CONDEA VISTA COMPANY

**ABERDEEN EXPRESS, PHASE 3
ABERDEEN, MS**

PROCESS HAZARD ANALYSIS REPORT

RAYTHEON ENGINEERS & CONSTRUCTORS

P&ID
RECYCLED CENTRATE PROCESSING
Boardman Express Project - Phase 3
BY: DY-093149-PID-D

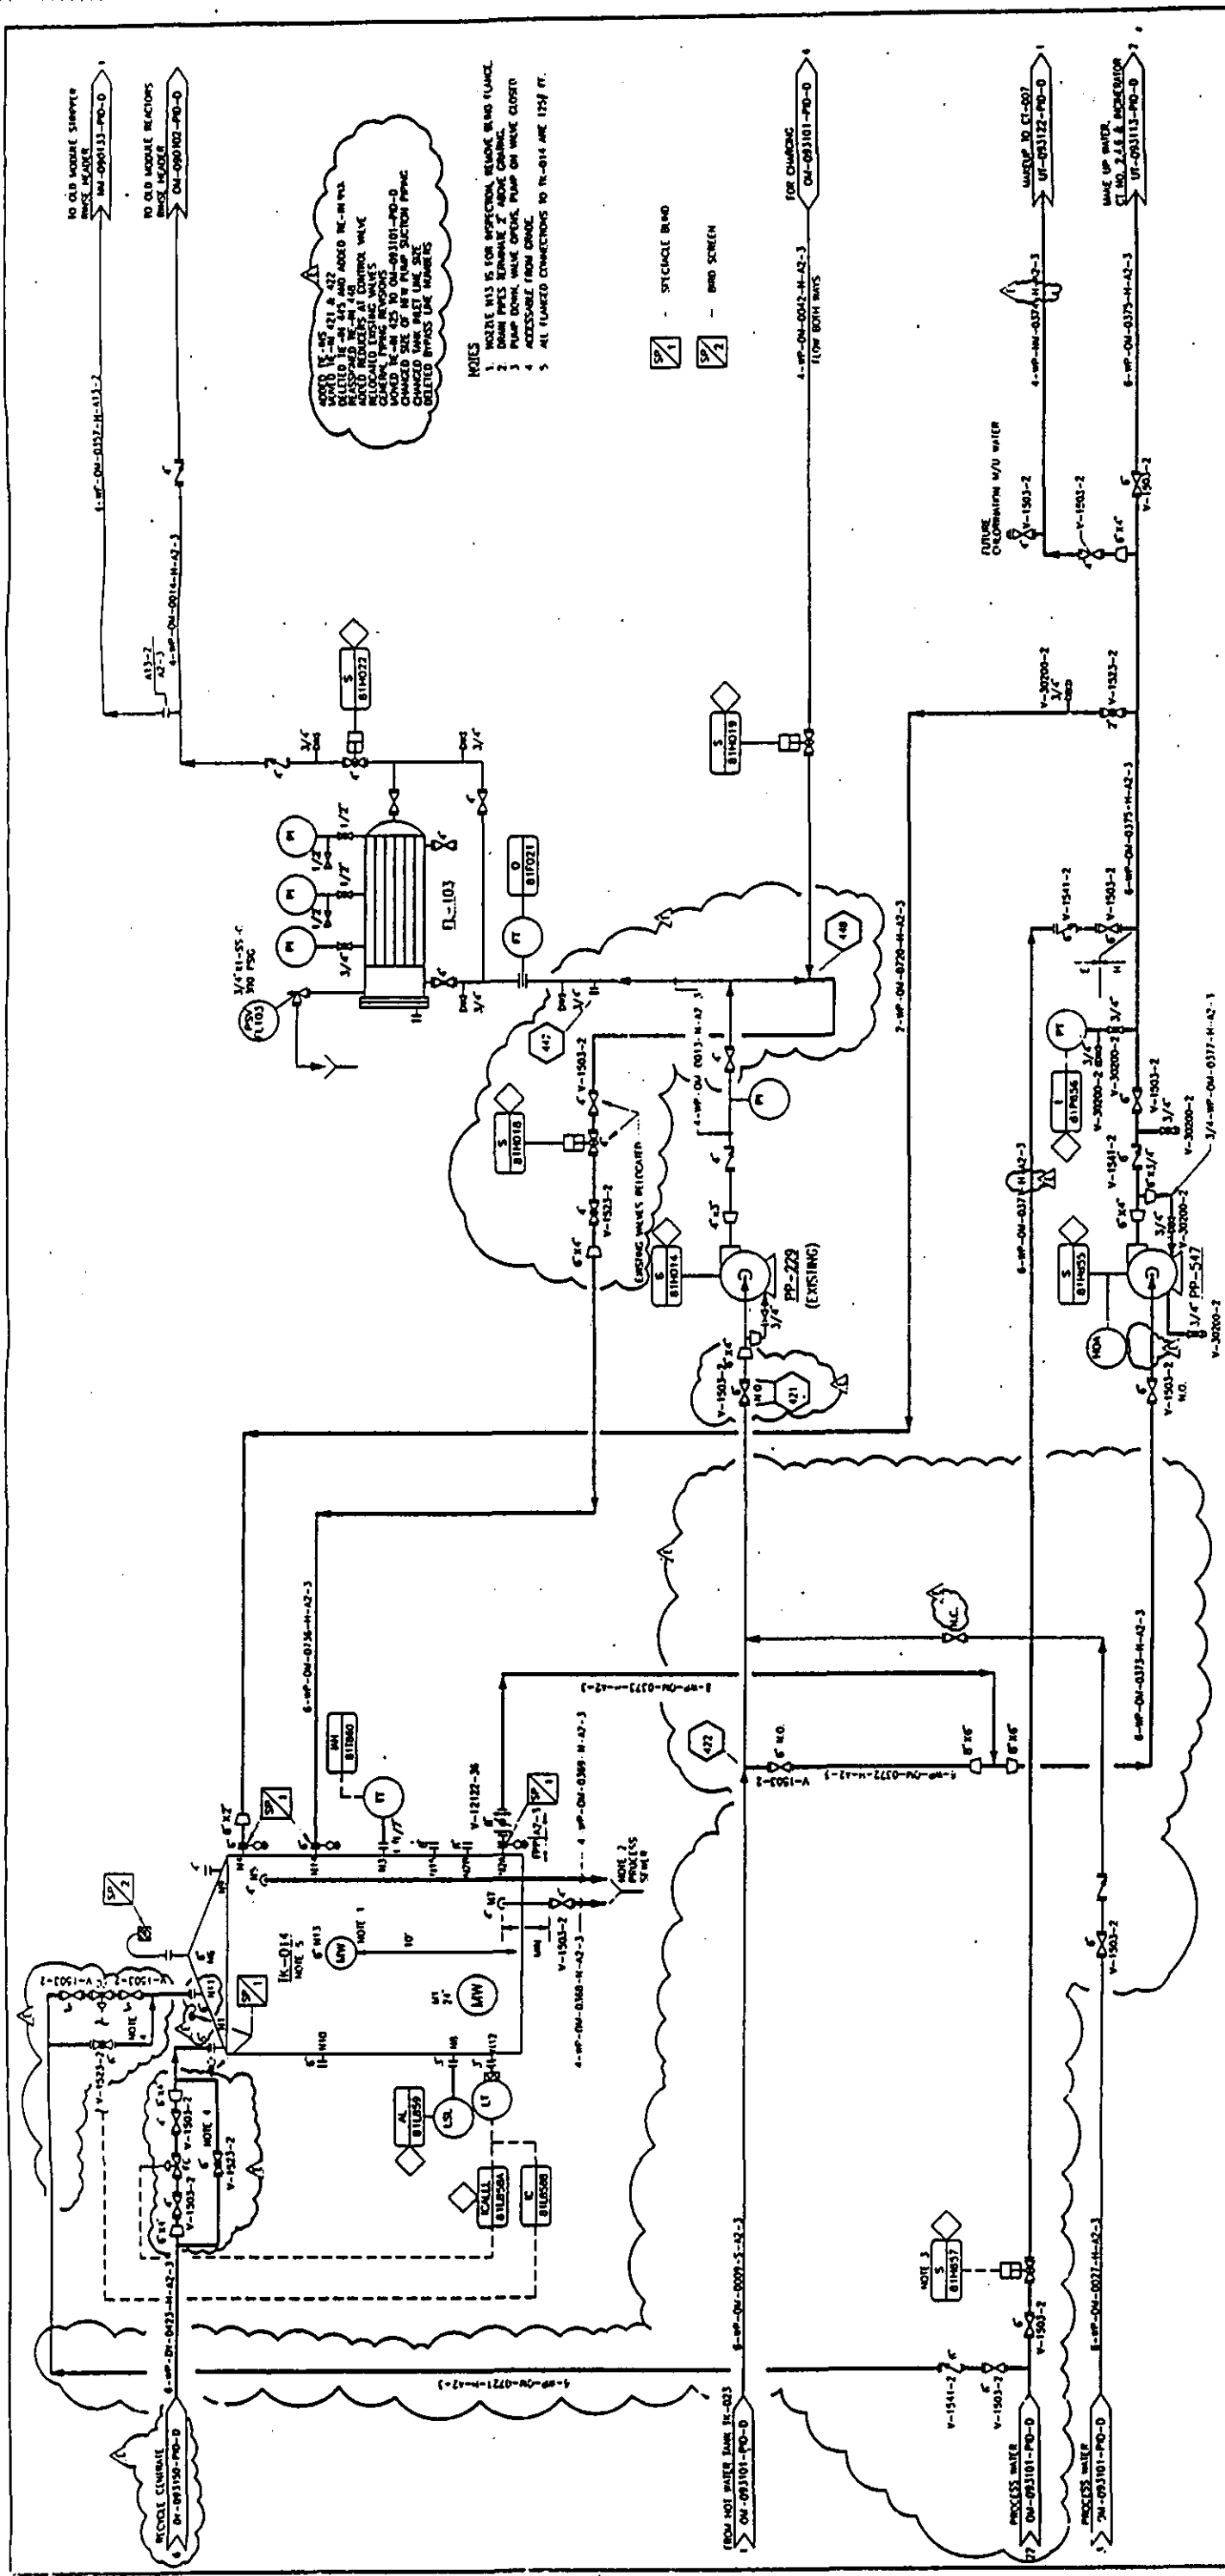
Item Number	Deviation	Causes	F	C	Consequences	FXETIBO	Safeguards	Actions
339.0 PROCESS LINE - PLANT AIR FOR SCOUR (dwg: DY-093149-PID-D)								
DESIGN INTENTION: SUPPLY AIR FOR FILTER BED SCOURING

339.1	NO / LOW FLOW	Operator error: manual valve closed Loss of plant air	4		Loss of scouring, incomplete backwashing	.4.....	SOP, training Pressure indication (84-PI-51002)

339.3	MISDIRECTED / REVERSE FLOW	Loss of plant air during scouring	3		Water in filter will get into air line	.4.....	Two checkvalves Pressure regulation (84-PCV-51008) Pressure indication	339 -1

Reference Number	Priority	Action	Responsibility	Status
328 -1	6	For water recycle chemical additives, consider some type of coding system or operating method to prevent an operator from hooking the wrong tote. (Item: 328.5)	Reed MacKay	
329 -1	8	Verify freezing point of sodium hypochlorite and determine if freezing could be a problem (Item: 329.5)	Reed MacKay	
334 -1	8	Review MSDS of water recycle chemicals to determine proper handling procedure. (Item: 334.1)	Reed MacKay	
339 -1	7	When writing the program for the media filter system consider operation in case of loss of air during the air scouring step. (Item: 339.3)	Reed MacKay
